Product Change Notification

Nature of Change:
Packaging

Affected Model:
BR-3032/BN and CR-3032/BN

Date of Notice:
January 4th, 2023

Details of Change

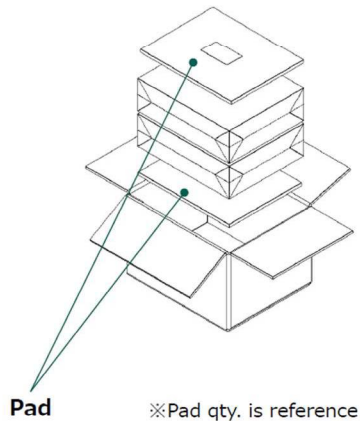
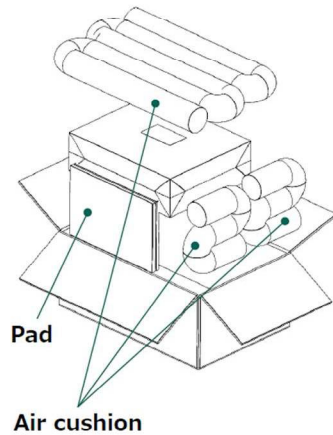
Panasonic would like to announce the packaging change to the BR-3032/BN and CR-3032/BN. The carton quantity will be increased from 200 pieces to 400 pieces.

The tray and inner packaging will not be changing.

Carton Spec	
BR-3032/BN	
Carton Dimensions	W: 188 L: 220 H: 149 mm
Carton Weight	3.25kg
Tray Quantity	20
Inner Packaging	200
Carton Quantity	400

Carton Spec	
CR-3032/BN	
Carton Dimensions	W: 188 L: 220 H: 149 mm
Carton Weight	3.25kg
Tray Quantity	20
Inner Packaging	200
Carton Quantity	400
